PRODUCT/PROCESS CHANGE NOTICE (PCN)

PCN #: **TB1903-01** DATE **April 8, 2019**

Product Affected: **5V2305NRGI**

ATTACHMENT I - PCN #: TB1903-01

Future Shipment : Cut-Tape Packing (1 to 100 units)

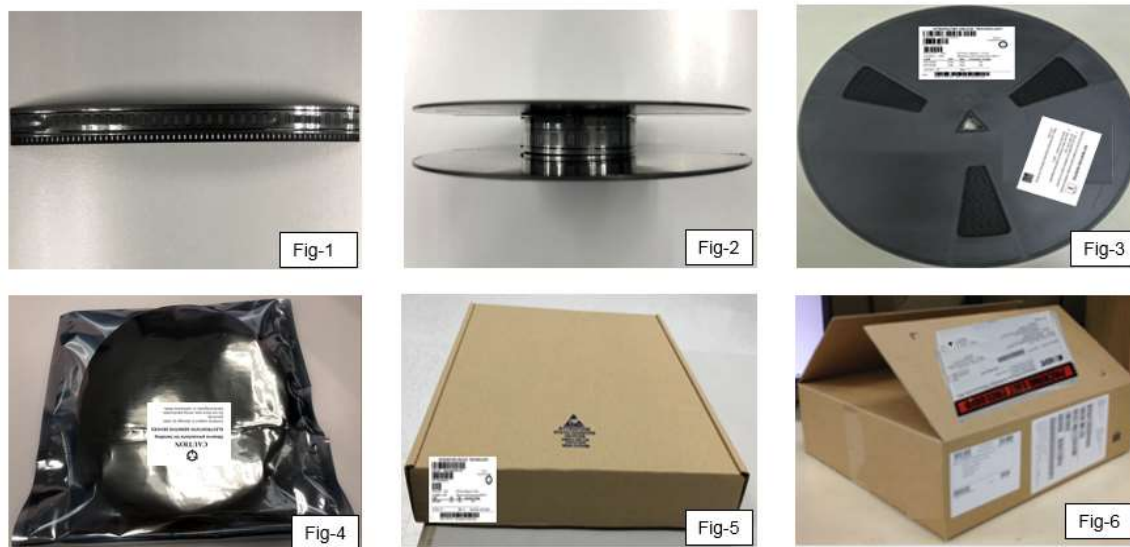
Detail of Change: This notification is to advise our customers that IDT will convert shipping media from Tube form to Cut Reel form. All the current labeling on carton boxes remain unchanged.

Note : Without Leader & Trailer empty pockets.
